Access Compliance Report Public Rights-of-Way (Curb Ramps)

Main Street: LEMON_ST Cross Street: VILLA_PARK_RD Location: NE

ADA ID: RPRK211222142400 Ramp Type: Type 1 - Perpendicular Initial Pass/Fail: Fail Overall Compliance: No Severity Score: 16

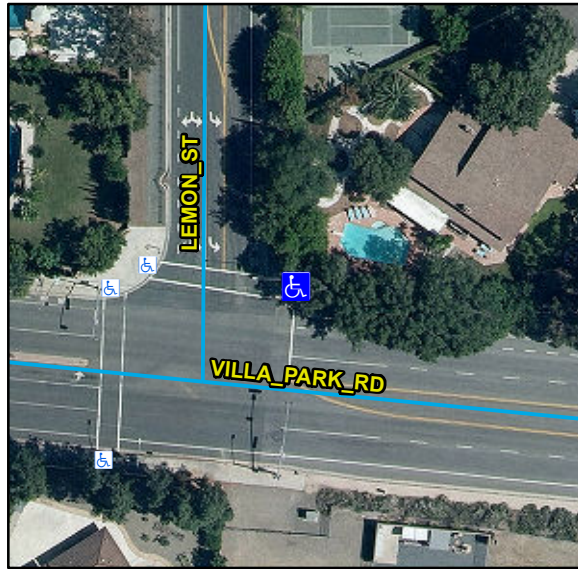
Compliance	Description	Data	Compliance	Description	Data
N/A	Ramp Length (in)	80	N/A	Flare Type LT	
Yes	Ramp Width (in)	48			N/A
No	Ramp Run Slope (%)	10.5	N/A	Flare Slope LT (%)	N/A
No	Ramp Cross Slope (%)	2.6	N/A	Flare Traversable LT	N/A
N/A	Landing Present	N/A	N/A	Flare Type RT	
N/A	Landing Length (in)	N/A			N/A
N/A	Landing Width (in)	N/A	N/A	Flare Slope RT (%)	N/A
N/A	Landing Run Slope (%)	N/A	N/A	Flare Traversable RT	N/A
N/A	Landing Cross Slope (%)	N/A	N/A	DWS Provided	N/A
N/A	Landing Movement Obstructed?	N/A	N/A	DWS Contrast	N/A
	Landing Movement Type	N/A	N/A	DWS Length (in)	N/A
N/A	Landing Shared	N/A	N/A	DWS Full Width	N/A
N/A	Clear Space	N/A	N/A	DWS Offset Left (in)	N/A
N/A	Clear Space To Crosswalk (in)	N/A	N/A	DWS Offset Right (in)	N/A
N/A	Marked Crosswalk 1	Yes	N/A	Marked Crosswalk 2	N/A
	Crossing 1 Direction	W		Crossing 2 Direction	N/A
	Marked Crosswalk 1 Width (in)	144		Marked Crosswalk 2 Width (in)	N/A

N/A	Ramp Inside Crosswalk 1	Yes	Yes	Ramp Inside Crosswalk 2	N/A
	Crossing 1 Slope (%)	4.2		Crossing 2 Slope (%)	N/A
	Crossing 1 Cross Slope (%)	0.4		Crossing 2 Cross Slope (%)	N/A
N/A	Gutter Ponding	N/A	N/A	Curb Slope	1.4
No	Gutter Lip Height (in)	0.5		Road Run Slope (%)	N/A
N/A	Gutter Run Slope (%)	N/A		Road Cross Slope (%)	N/A
N/A	Gutter Cross Slope (%)	N/A			
Yes	Overall Surface Condition: Acceptable		No	Perp Joint Present	No
	Cross Gutter Present?	No		Spandrel Present?	No
	Replace Cross Gutter?	N/A		Replace Spandrel?	N/A

Remove & Replace Entire Ramp. Grind Gutter Lip.

R204.3, R304.2.2, R304.5.3, R302.7.2, STD 1115
